**Agenda item:** Release 2000 issues  
**Source:** Nokia  
**Title:** Remarks on the proposal for the improved cell RACH/FACH state  
**Document for:** Discussion (RAN WG1), Information (RAN WG2)

Annex 1: The Comments to the Questions in R1-00-0678 (Comments from GBT are indicated with revision marks)

**FIGURE 1. CLPC FACH Timing.**

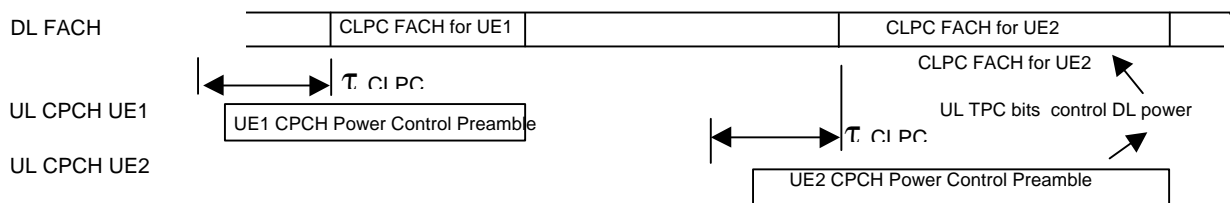
b) What is the minimum and max delay required between FACH "paging" and actual packet on the FACH? What does the calculated delay consist of (UE processing, CPCH procedure, Node B-RNC delay etc.)? Are CPCH procedure error events included?

(5) The scheduling delay is deterministic and includes the:

1. UE processing
2. CPCH Access Ramp up
3. CD phase
4. pre-data power control

Note that 1 or more PCPCH channels are reserved for this purpose and there is no contention in this phase.

Also the scheduling time, the UE id, and the pcpch access preamble are sent on the scheduling message.

$$\tau_{CLPC} = (N_{ap\_retrans\_max} + 1)\tau_{next\_slot} + 5.28msec,$$

$$\begin{aligned} \text{where } \tau_{next\_slot} &= \text{Time to next available access slot, between Access Preambles.} \\ &= 3.75ms + 1.25ms \times T_{cpch} \text{ (CPCH timing parameter)} \end{aligned}$$

Note that this is equivalent to:

$$\tau_{CLPC} = [\text{max period from first AP to start of PCP}] + [8 \text{ slot length PCP}]$$

Figure 1 below shows an overview of the CLPC FACH timing between the Node B and the UEs.
